# Input for HEV power determination From Japan

# Power Determination Validation Program

EVE teleconference

February 13, 2019

# Background on the measurement problem

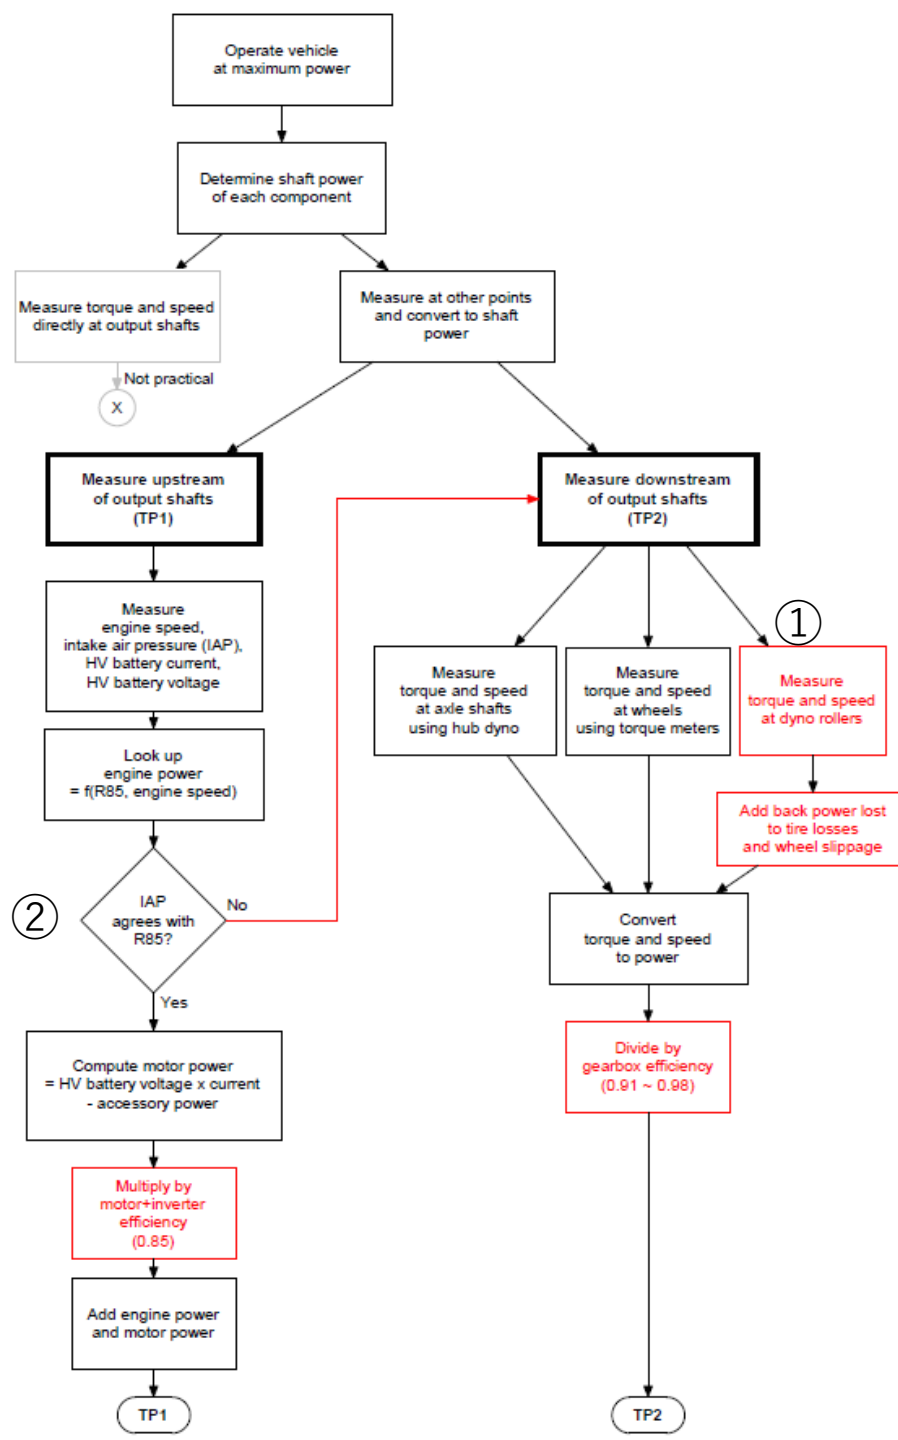
Fully Agreed
